**NHTSA Safety Recall
No. 14V-327**

QA 11-04**QUALITY ALERT**

Pressure Switch and Exhaust Thermal Blanket Inspection

Figure 1 — Thermal Blanket

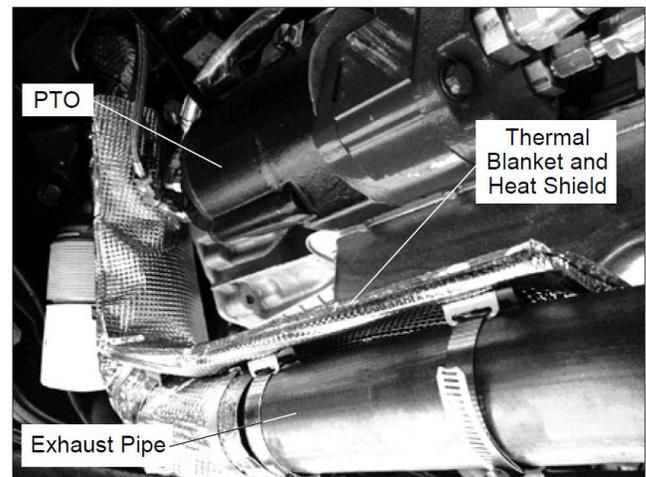
Stahl/Arbortech has been made aware of a possible issue concerning a pressure switch and exhaust thermal blanket (Figure 1) provided by the supplier of the power take off (PTO). Over time, the pressure switch can develop a low volume transmission fluid leak and the exhaust thermal blanket can deteriorate causing it to absorb hydraulic oil or transmission fluid. A buildup of oil or transmission fluid on the thermal blanket may increase the possibility of a fire. **Death or serious injury can result from a chassis fire.**

There is a Pressure Switch Relocation Kit, part number 43TK5532 available to move the switch away from the exhaust. This kit includes a new pressure switch, tubing, and adapters. If the exhaust thermal blanket fails the inspection and/or there is evidence of a pressure switch leak, remove the exhaust thermal blanket at the time of the inspection and install an improved Exhaust Heat Shield Kit, part number 970510446, within 30 days of removal of the exhaust thermal blanket. Pressure switches that pass the inspection must still have the Pressure Switch Relocation Kit installed at the next service interval.

Order the Pressure Switch Relocation Kit, part number 43TK5532 and Exhaust Heat Shield Kit, part number 970510446, by calling 1-800-277-8245.

Figure 2 — Front Pressure Switch Location

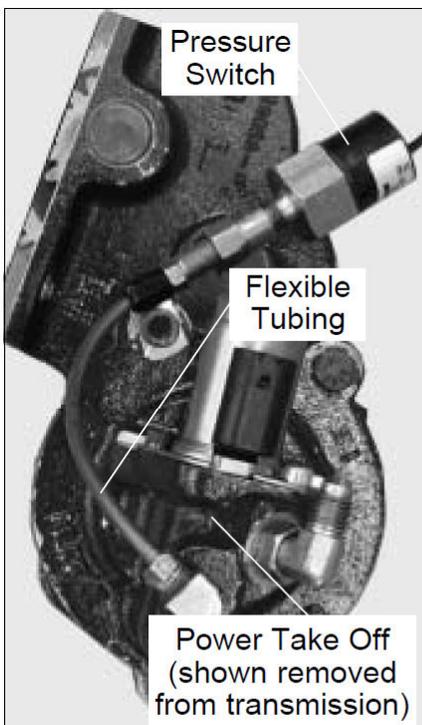
1. Position unit on a level surface, apply the parking brake and chock the wheels. Shut off engine and allow the chassis exhaust system to cool to the touch.
2. Using a mechanic's creeper, get under the chassis near the PTO on the driver's side of the transmission.
3. Find the thermal blanket that is attached with band clamps to the exhaust system near the PTO.
4. Use your hand to determine if the thermal blanket is wet with fluid. Look at the pressure switch to see if it is leaking transmission fluid. The pressure switch is located either on the front side of the PTO connected to a flexible tube (Figure 2) or on the side near the rear of the PTO connected to a formed tube (Figure 3.)
